# DEVIATION REQUEST AND DECISION FORM

Project Name :	Crossroads Mixed-Use Preliminary Plan
Schedule No.(s) :	5408007005
Legal Description :	A portion of Tract B 24/94 Business Park Fil No. 1, as amended by affidavit of correction rec. #219097386

A deviation from the standards of or in Section **2.3.7.E.1 & E.3 and Table 2-25** of the Engineering Criteria Manual (ECM) is requested.

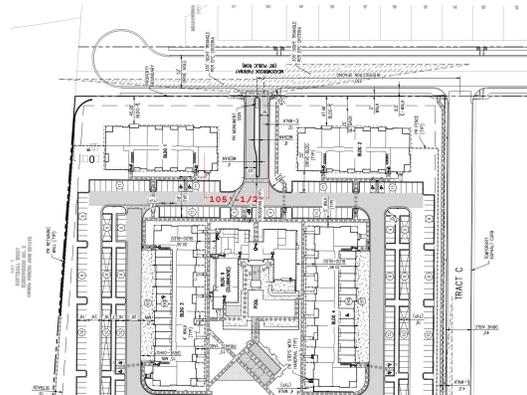
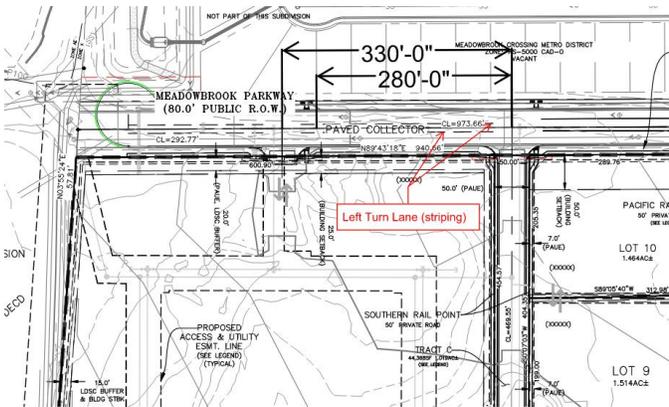
205-foot left turn lane consisting of 155-foot deceleration lane length and 50-foot storage with a 160' taper is required per the ECM.

330-foot spacing exists between the "West" access (multifamily driveway) on Meadowbrook and the "Middle" access (Southern Rail Point). According to the TIS, there is approximately 260 feet of available space for a westbound left turn lane at the west access due to the proposed location of the middle access.

Since there are geometric constraints with reconfiguring buildings on site, supporting traffic analysis has been provided that includes justifications for why the westbound left turn lane at the west access from Meadowbrook parkway can be accommodated in the current location. An image of the preliminary plan and development plan call out are provided below for reference. (Images are not to scale)

Alternative Turn Lane Design to provide 50-feet of storage length (standard), and 50-feet (per deviation) of deceleration lane length (substandard), and a 160-foot taper (standard) within the westbound left turn lane at the "west access" along Meadowbrook Parkway to accommodate spacing restrictions. The taper (160') and storage (50') meet criteria, the decel lane (50') is required to be 155-feet; can be accommodated.

The design plan sketch has been updated to be larger and now provides a total length of 260 feet instead of the previous 280 feet while updating the individual length components.

This request has been determined to have met the criteria for approval. A deviation from Section 2.3.7.E1 &E3 table 2.25 of the ECM is hereby granted based on the justification provided.
